**LATHAM & WATKINS** LLP

Re: Ashland Lakefront Superfund Site:  
Response to September 23, 2014 Weston Dry Dredge Report

# POINTS OF CONCERN REGARDING WESTON 2014 DRY DREDGING EVALUATION ASHLAND LAKEFRONT SUPERFUND SITE

Anchor QEA, LLC

| Figure 1 | Compound Effects of Aggressive Assumptions in Weston's Analysis |

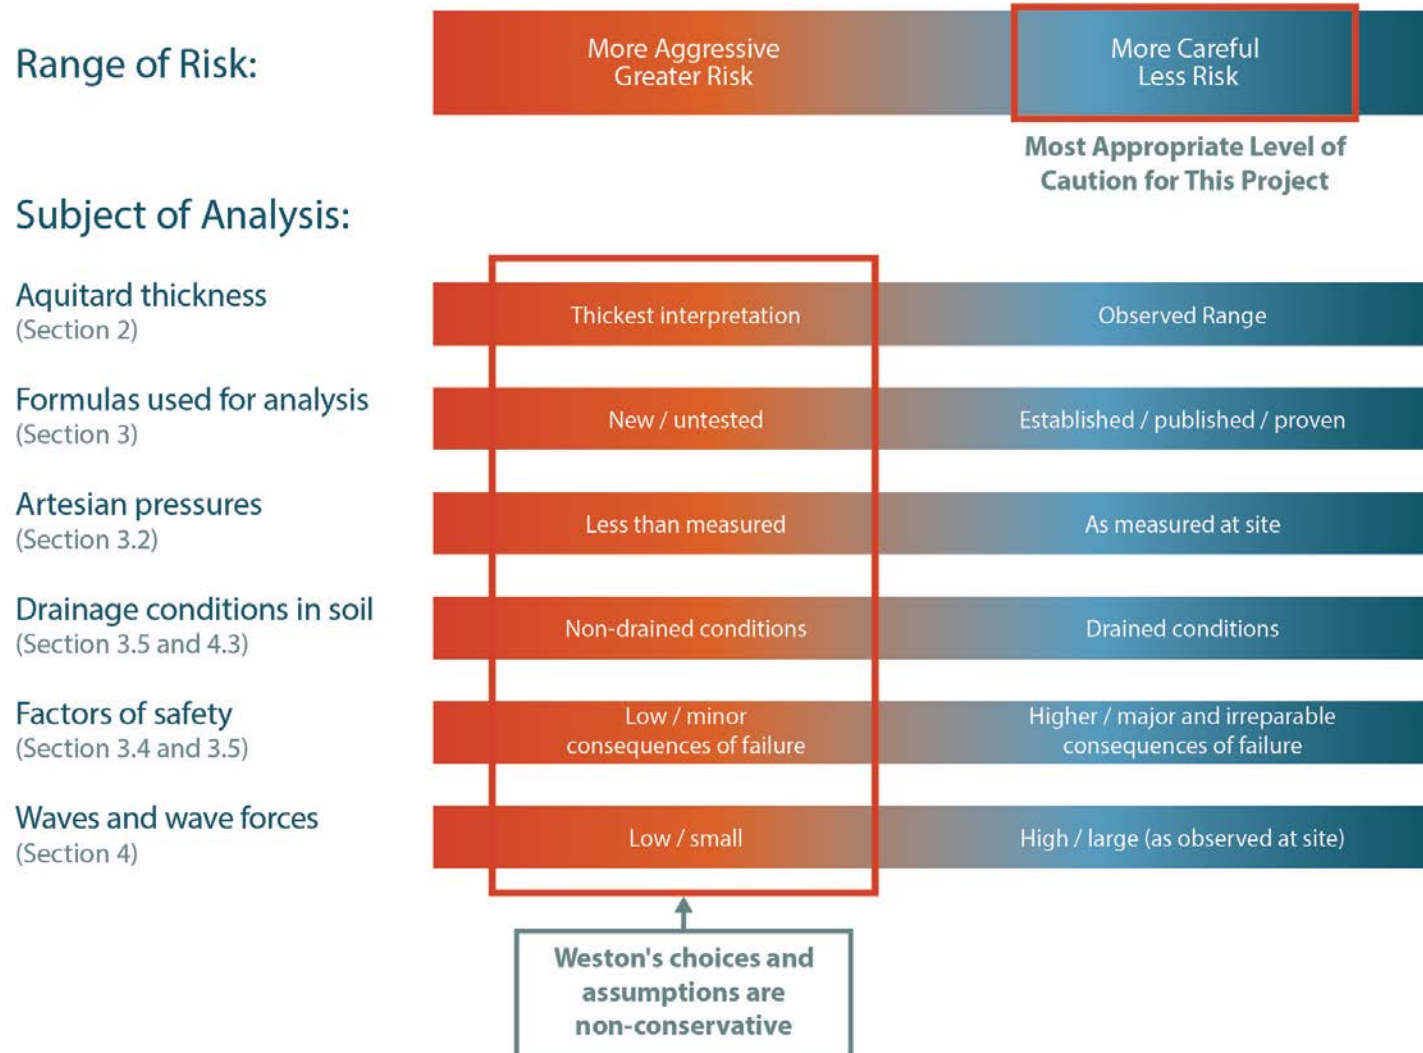
Figure 1 presents a representation of how Weston's analysis combined a number of aggressive choices and assumptions, resulting in a conclusion that pushes an experimental, unproven, and risky approach to the remediation of this Site. The figure presents six separate rows, each representing a choice or assumption used in evaluating dry dredging. For each subject of analysis, Weston has made aggressive assumptions, and in some cases the most aggressive assumption possible. The subjects of analysis listed in Figure 1 and discussed in detail later in this report, are as follows:

- **Aquitard thickness.** In cases where there is some question about the relevant thickness of the stabilizing Site aquitard layer, Weston has selected the thickest possible assumption. If the average, or thinner end, of the observed thickness is used in the calculations, actual risks of failure are greater than Weston's method.

- **Waves and wave forces.** Weston has selected relatively low wave loads—lower, in fact, than those experienced at the Site in the fall of 2014—and has also derived relatively low loading forces from the waves acting on the surrounding sheet pile walls. For example, Weston assumes the following: (1) pressure from waves breaking against the sheet pile wall will be less than the pressure from non-breaking waves; and (2) significant waves will never break against the sheet pile wall.

- **Artesian pressures.** In cases where there is some question about the magnitude of the artesian groundwater pressure applied to the basal heave analysis, Weston has applied reduced artesian pressures (lower than measured) acting below the surface. If observed artesian pressures are used in the calculations, actual risks are greater than Weston's hypothetical scenario.

As depicted on Figure 1, the end result of Weston's evaluation, when each step is compounded, is an aggressive and risky approach, rather than an appropriately cautious and safe approach, that recognizes the very real and severe consequences of failure at this Site.

Project Name: Weston Drained Both Sides AQ-SB-04  
Date: 12/11/2014  
Author: JTaylor  
Company: Anchor QEA, LLC  
Comment: Trial run of Weston design using drained conditions on both sides.

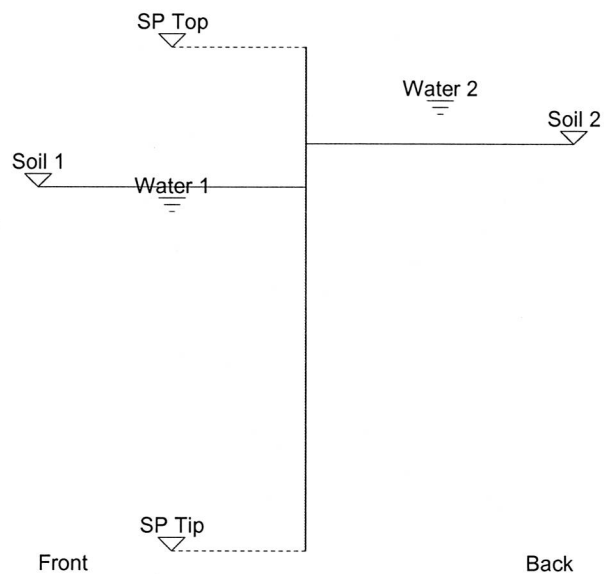
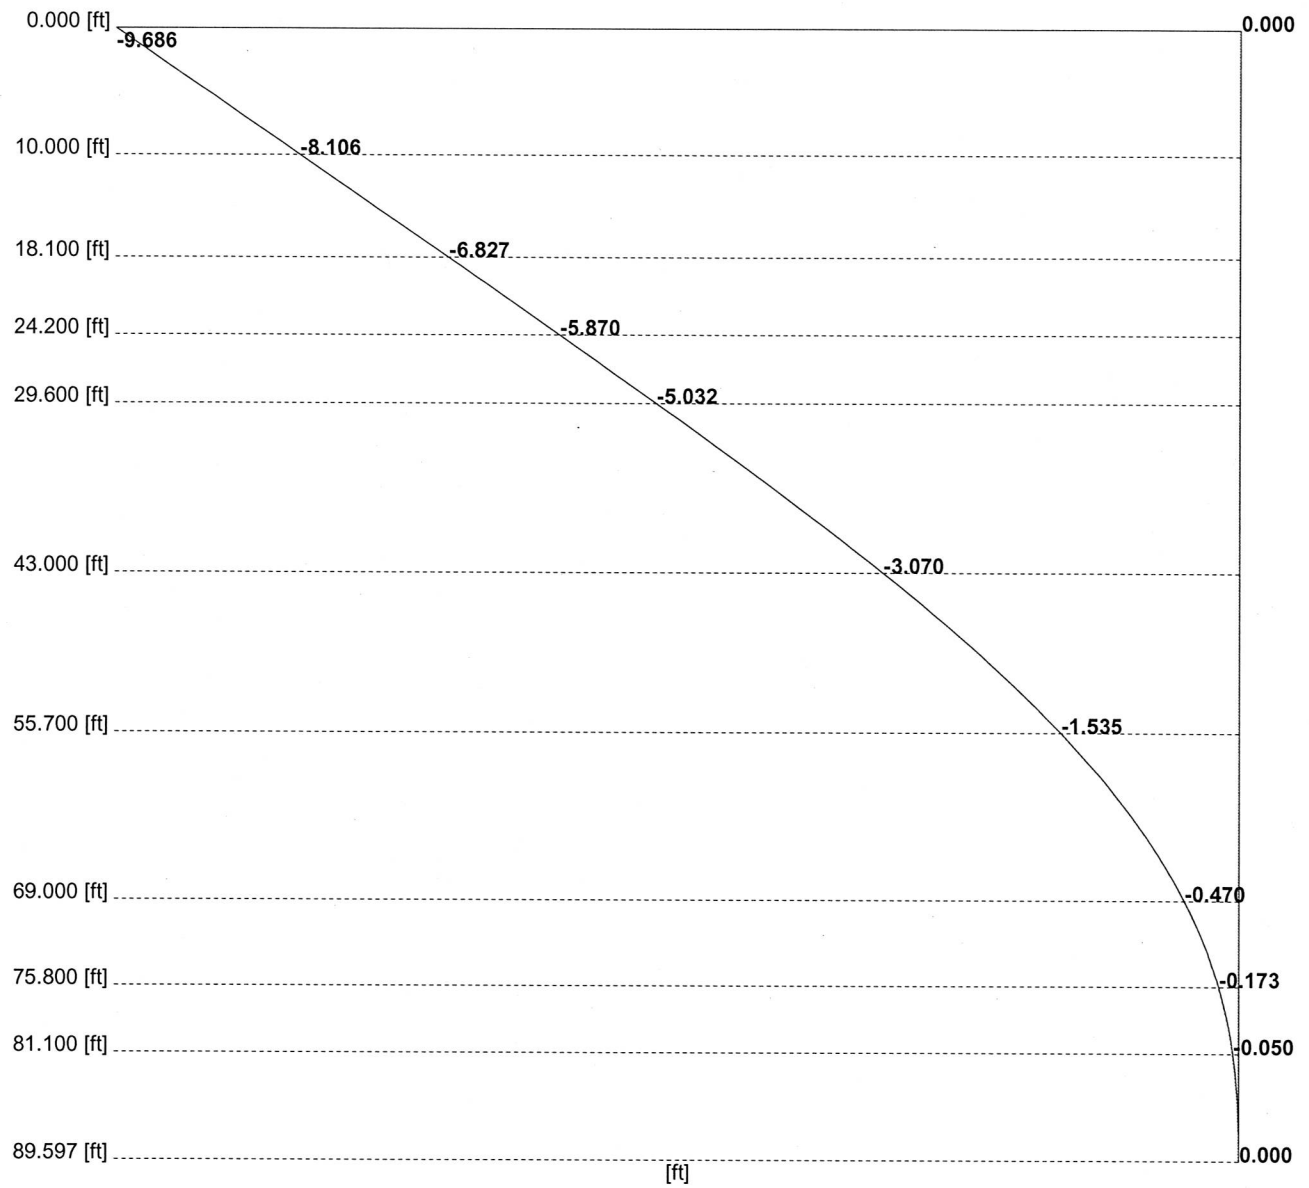
The use of the ProSheet computer program, as Weston used, is a standard industry practice for sheet pile selection. However, in their use of the program, Weston has not fully accounted for the possibility that drained conditions could develop during the excavation process. The importance of this consideration is described above, in Section 2.3. While Weston applied drained soil parameters on the retained (outer) side of the wall, they used undrained soil parameters on the excavated (inner) side, and did not evaluate the possibility that drained parameters could also apply on the inner, excavated side of the wall.

When the same ProSheet sheet pile analysis is conducted using drained soil parameters on both sides of the wall, the Factor of Safety is much lower. The results are included as Appendix A to this report.
